DEPT. OF
ROYAL PALM BEACH
BUILDING DEPARTMENT
Reviewed for Code Compliance
[Signature]
JAN 3 7 2003
Inspector

COUNCIL CHAMBERS
FOR
THE VILLAGE OF ROYAL PALM BEACH
FLORIDA

Issue
May 10, 2002
Revised
Nov 1, 2002

FLOOR PLAN - 3011 S.F.

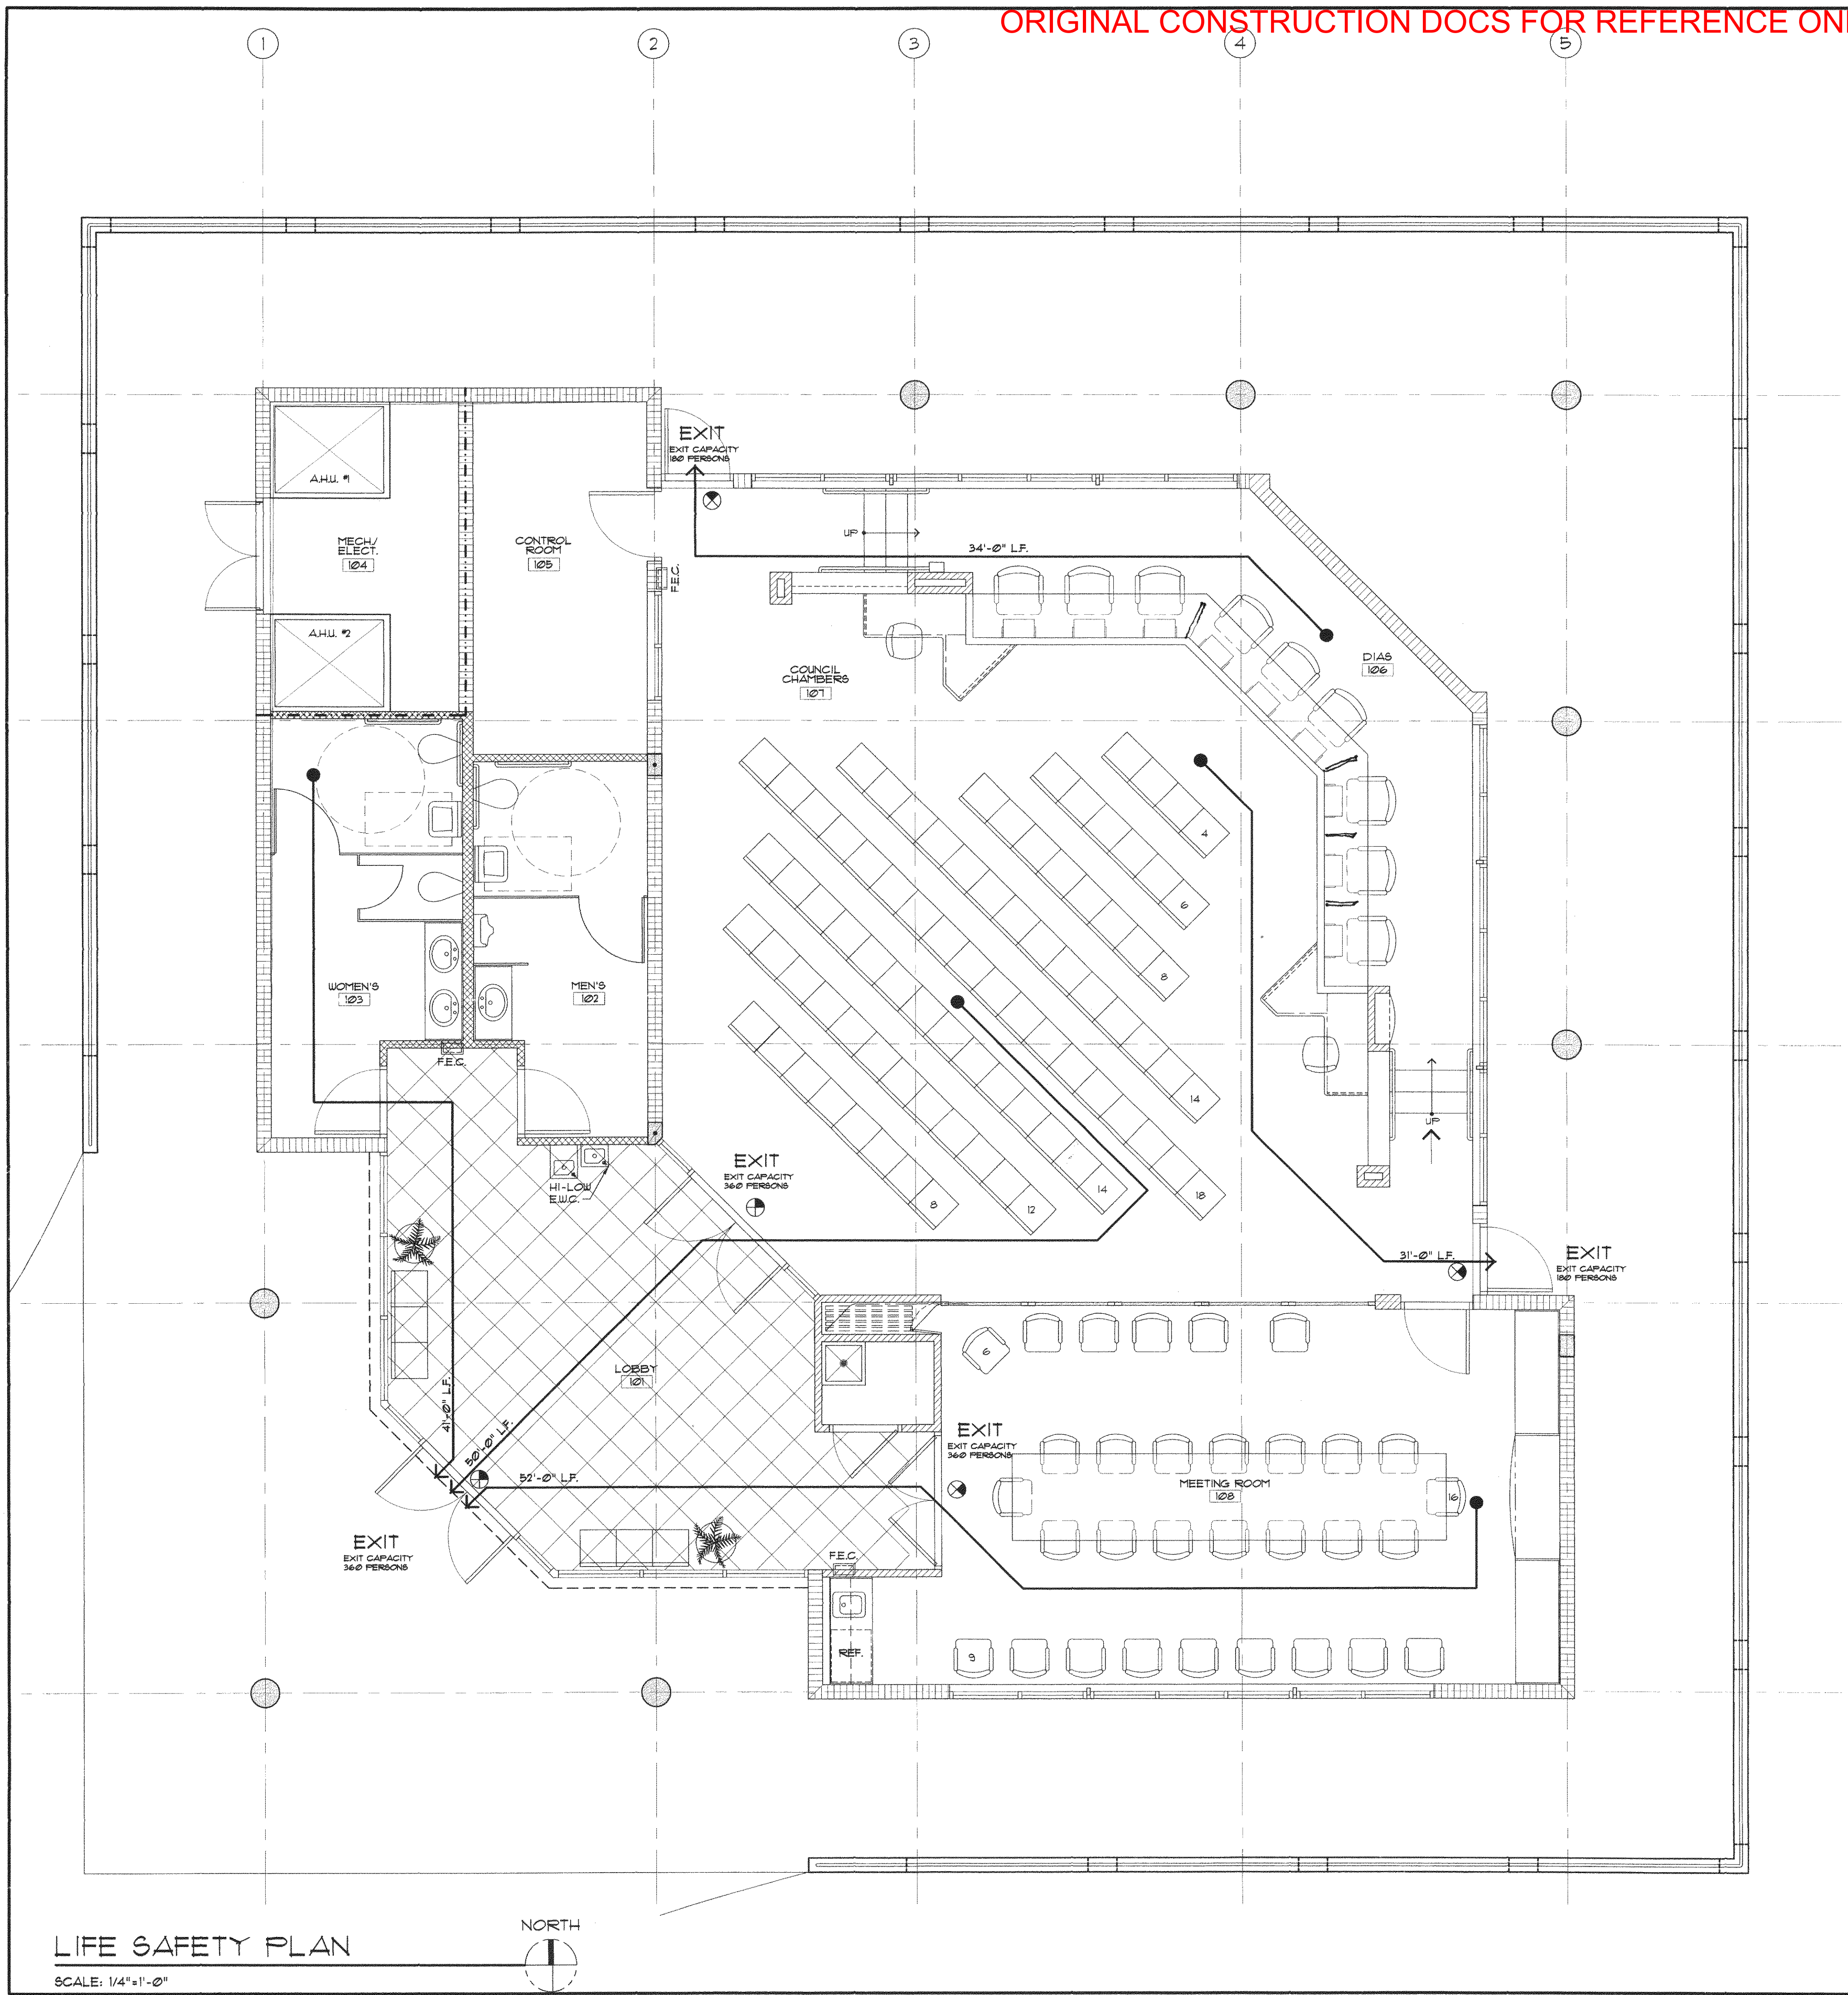
FIRE EXTINGUISHER(S) REQUIRED MINIMUM SIZE 7A-10BC MAXIMUM TRAVEL DISTANCE 75 FT MUST HAVE INSPECTION TAG

FIRE INSPECTION REQUIRED AT TIME OF FRAMING

ADDRESS NUMBERS SHALL BE PROVIDED AND BE PLAINLY VISIBLE AND LEGIBLE FROM THE STREET AND FROM REAR OF BUILDING

8
A3.2 SCALE: 1 1/2"=1'-0"
STAIR & RAIL DETAIL

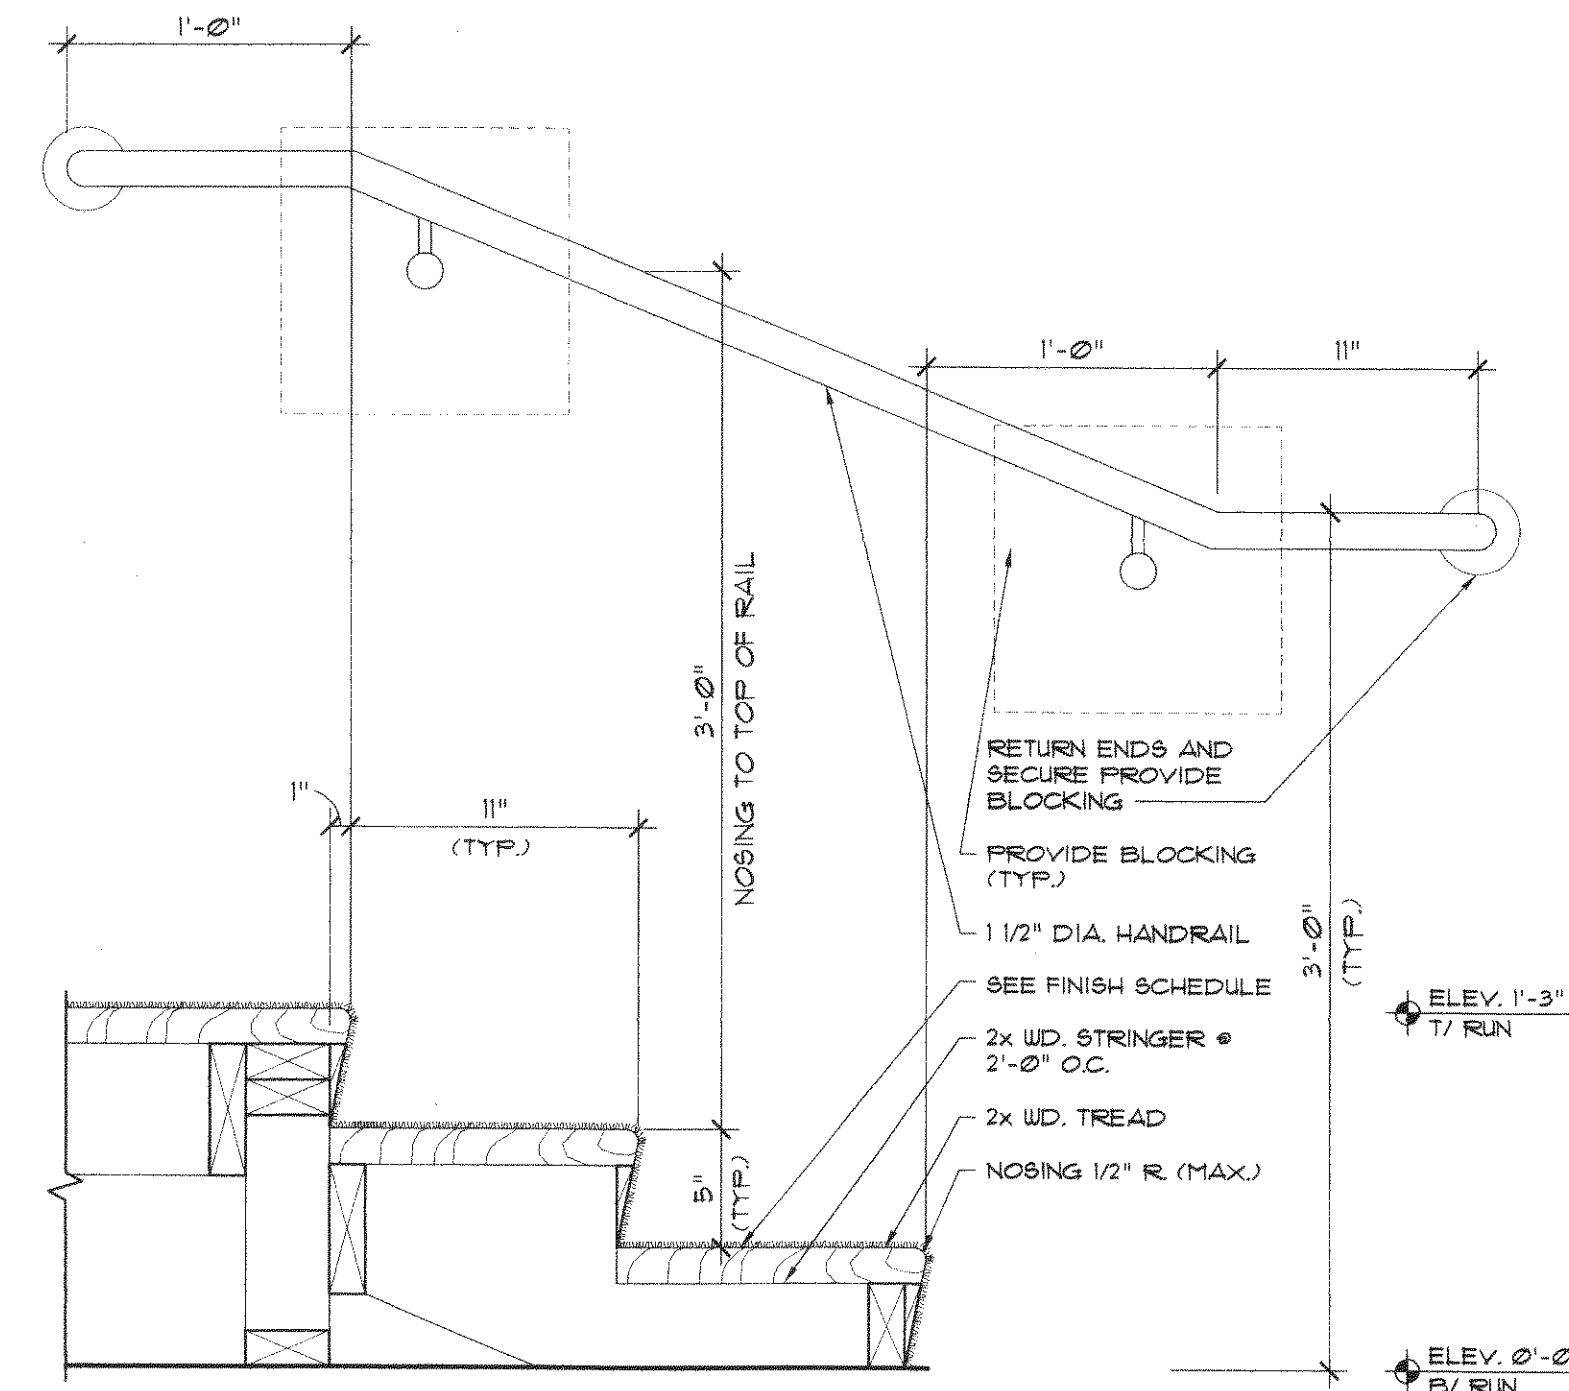
HANDRAILS REQUIRED ON BOTH
SIDES OF STAIRS

Handrails To Terminate To
Wall, Floor, Or Newel Post

HANDRAILS SHALL BE GRASPABLE
TO PERMIT SOME LOCKING ACTION
BY FINGERS AS THEY CURL AROUND
THE HANDRAIL
